**SEQUOYAH NUCLEAR PLANT (SQN) - UNIT 2 - RESPONSE TO NRC
REQUEST FOR ADDITIONAL INFORMATION REGARDING LICENSEE
IDENTIFIED MATERIAL WASTAGE (TAC NO. MB4579)**

TENNESSEE VALLEY AUTHORITY
SEQUOYAH NUCLEAR PLANT (SQN)
UNIT 2
DOCKET NO. 328

ADDITIONAL INFORMATION REGARDING
LICENSEE IDENTIFIED MATERIAL WASTAGE

PHOTOGRAPHS FROM THE UNIT 2 INSPECTION

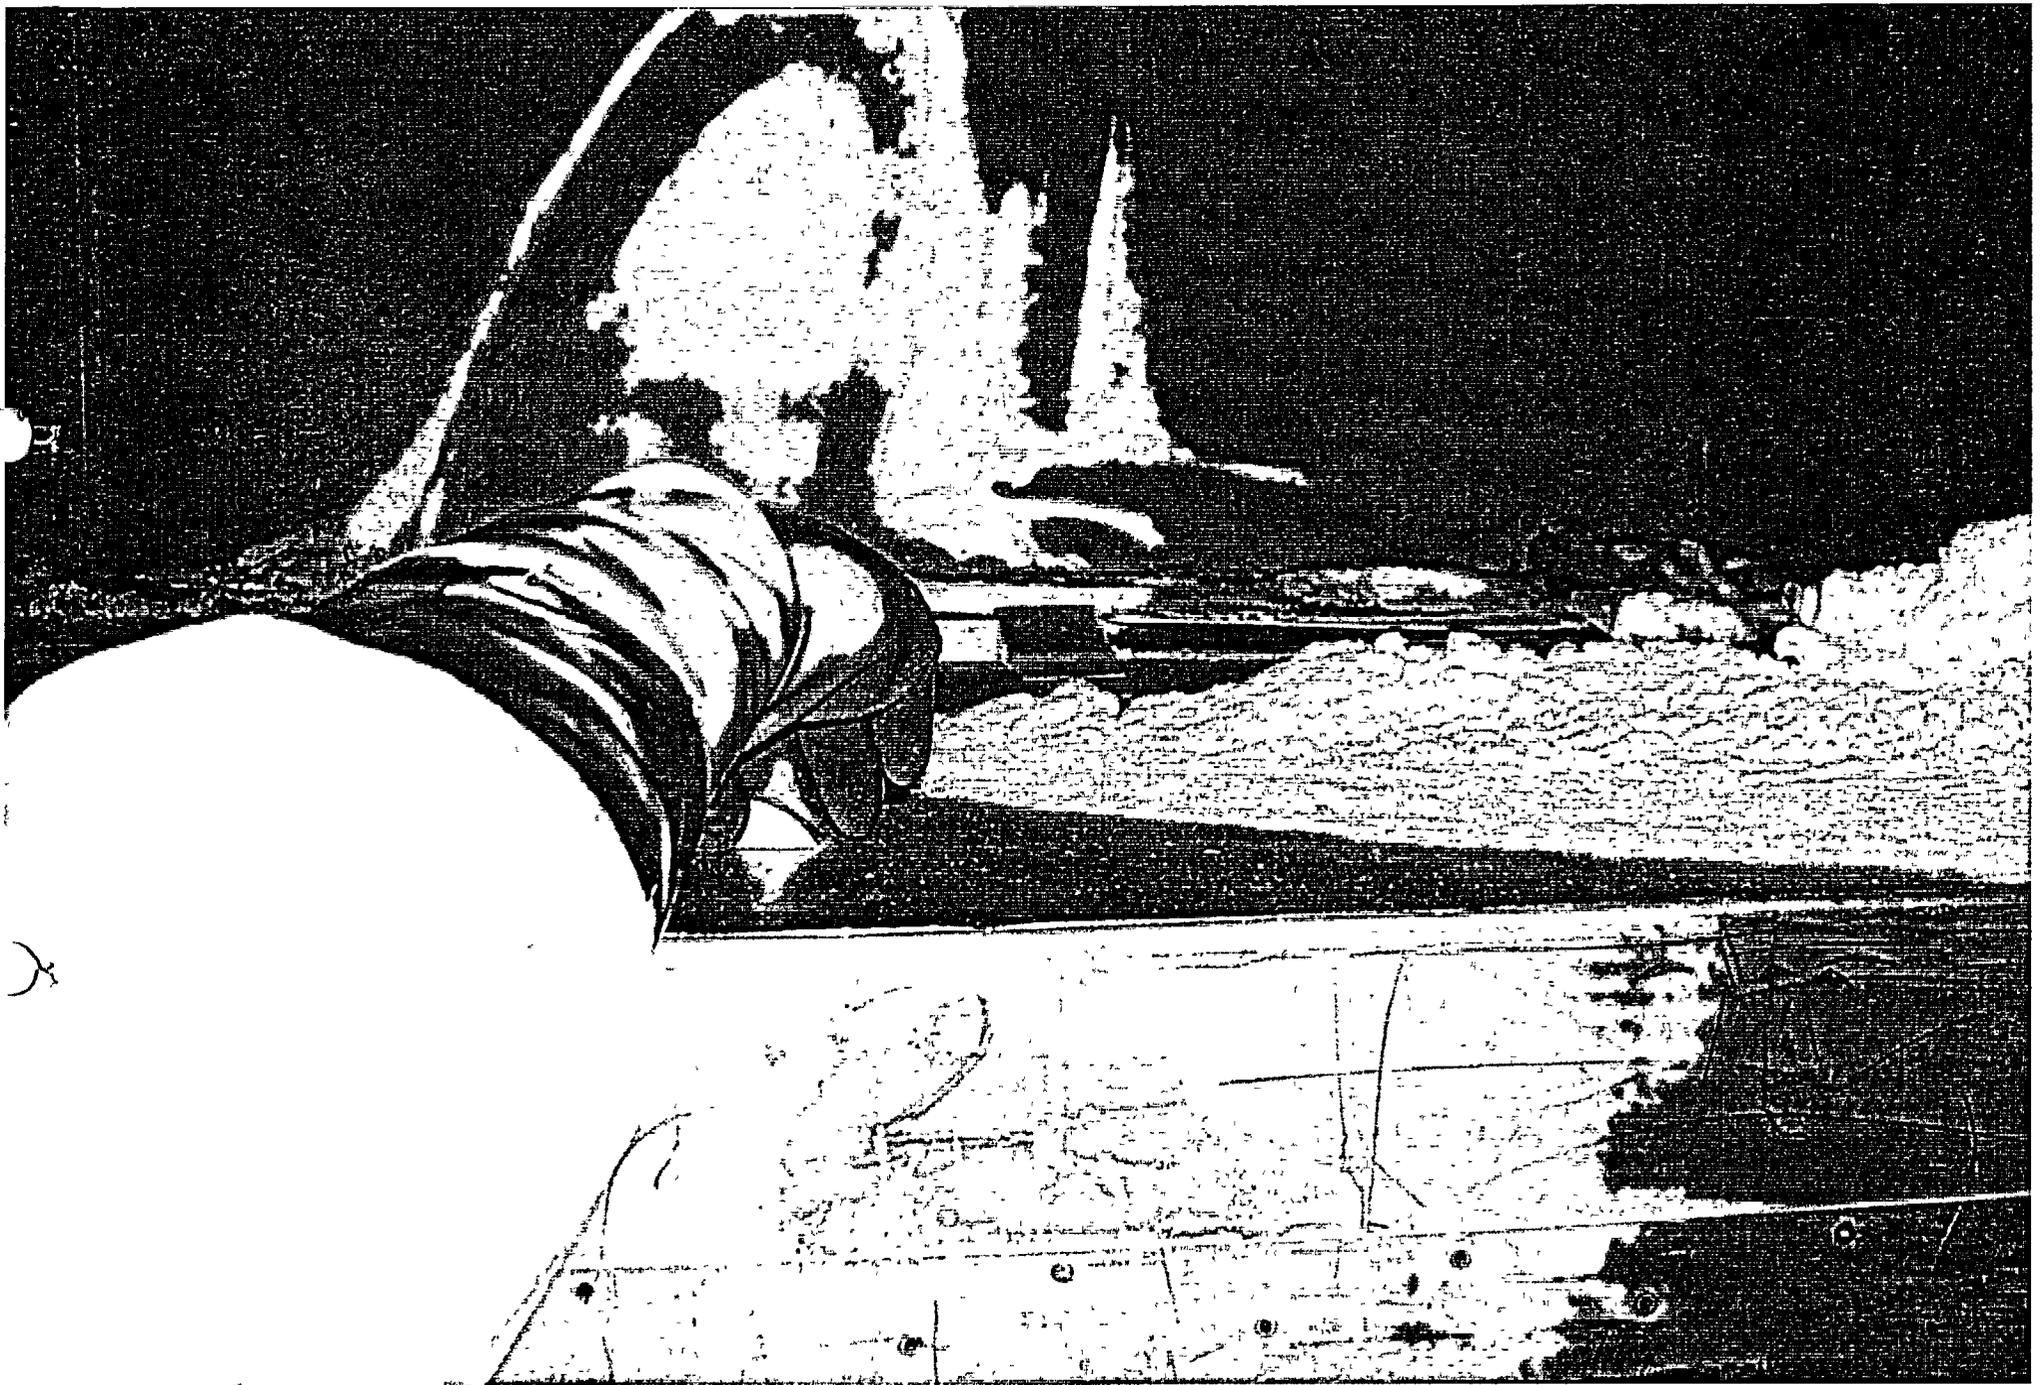
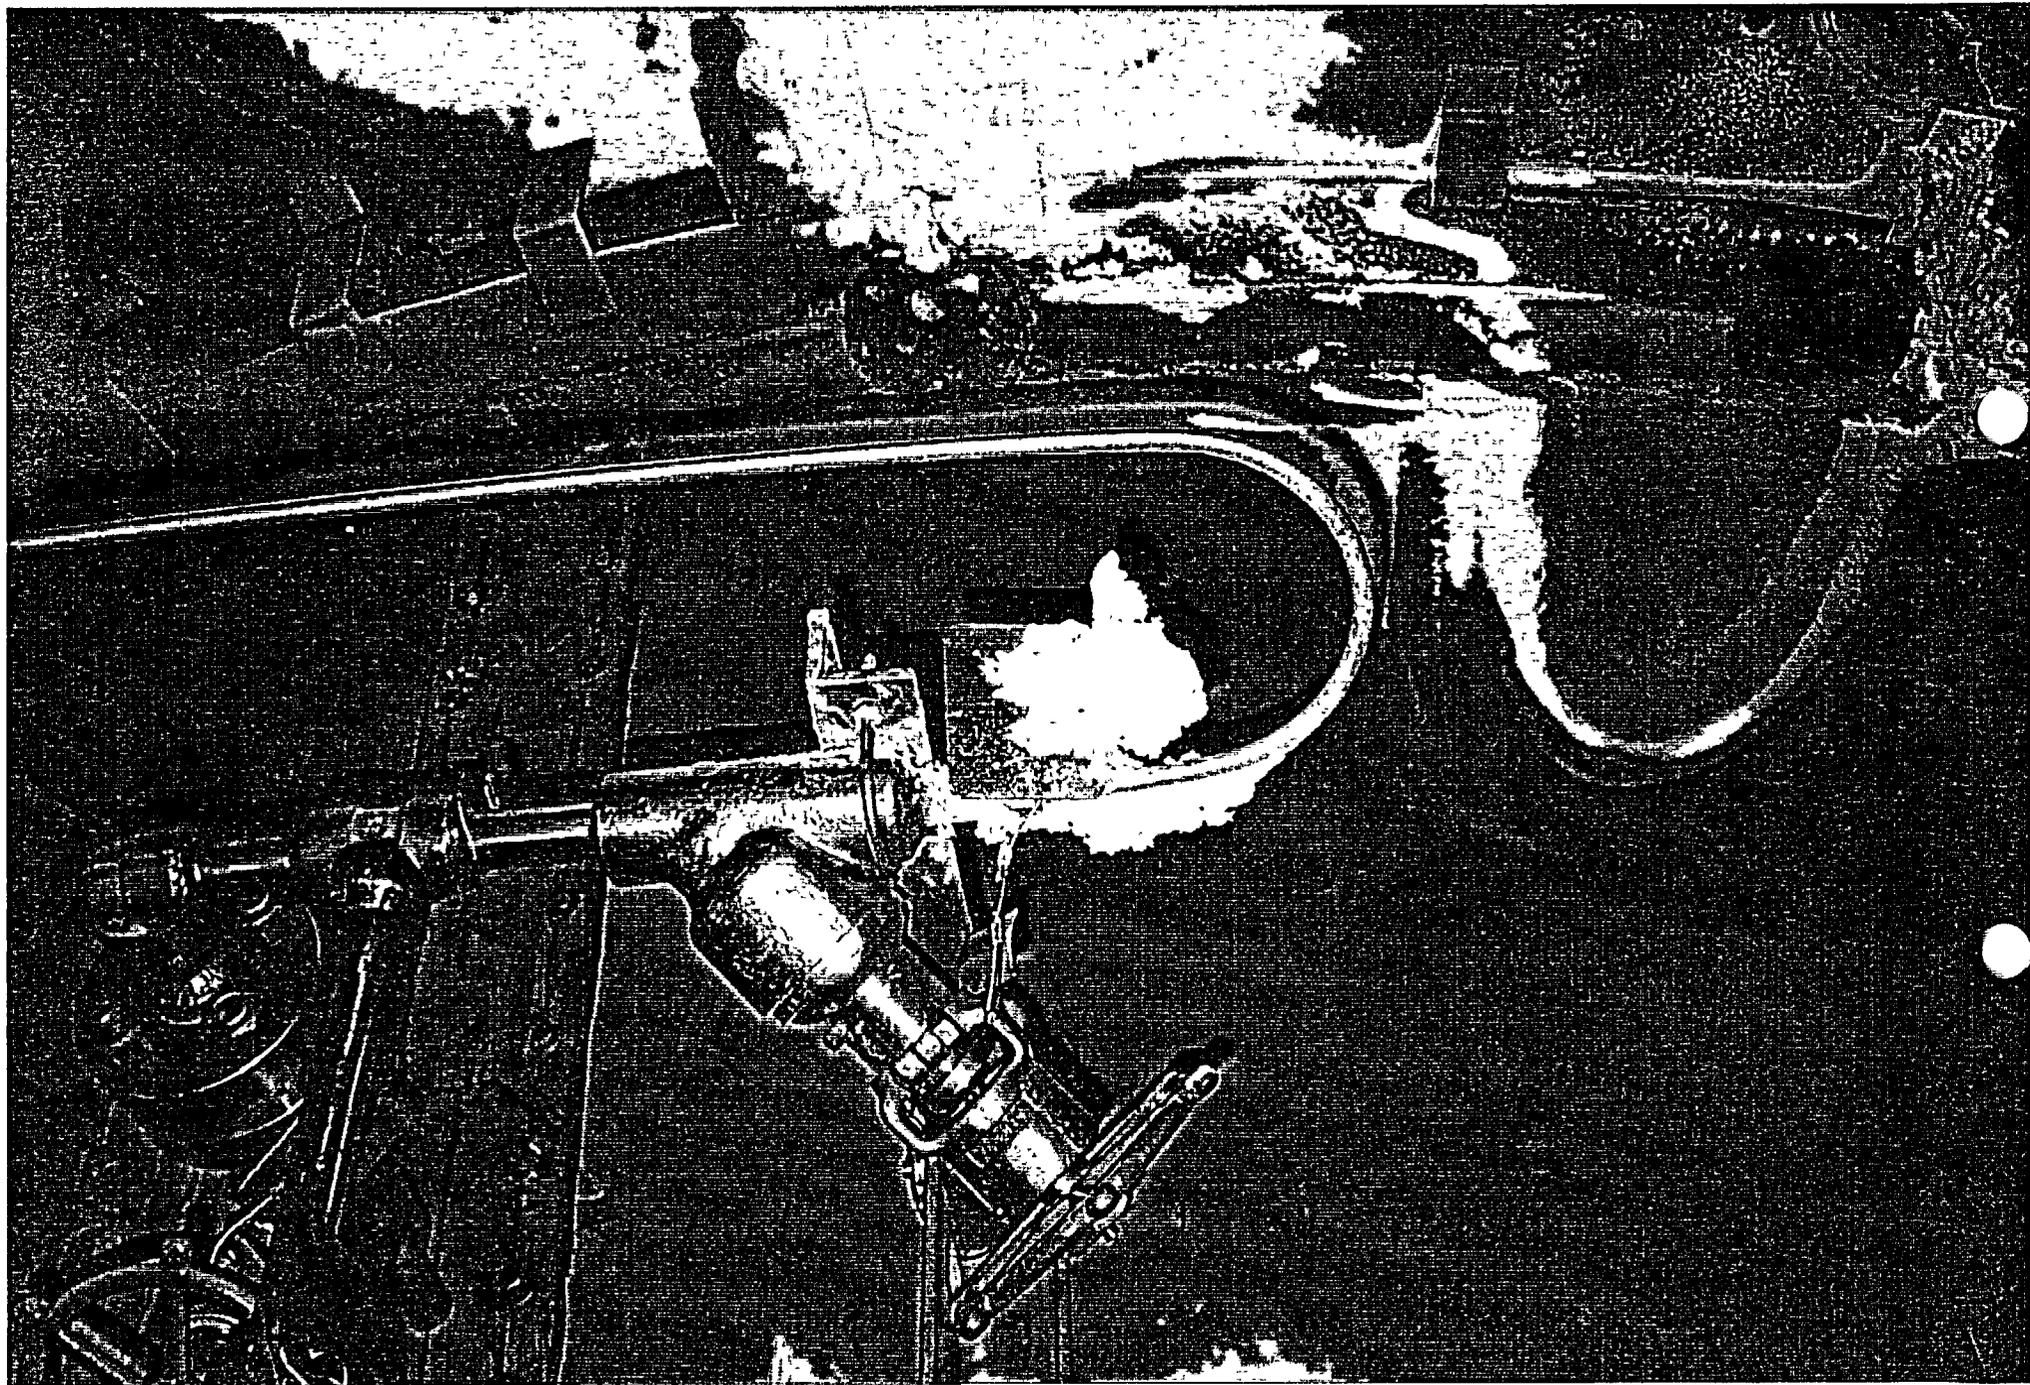
What is the trend of reactor coolant system (RCS) unidentified leakage since the last refueling outage and how well does the amount of boron recovered correlate to the known trend of RCS unidentified leakage? What is the location of insulation seams in the vicinity of this degradation? What is the distance between the leaking RVLIS mechanical joint and the top of the

As can be seen from the enclosed photographs (see enclosure 2), the RVLIS connection protrudes through the CRD shroud above the insulation over the vessel flange bolting. The RVLIS leak resulted in a spray pattern on the vertical insulation. The process fluid that remained in liquid form then progressed to the insulation seam joint and dripped on the reactor vessel head. The distance from the RVLIS mechanical joint to the reactor vessel head is approximately 4 feet.
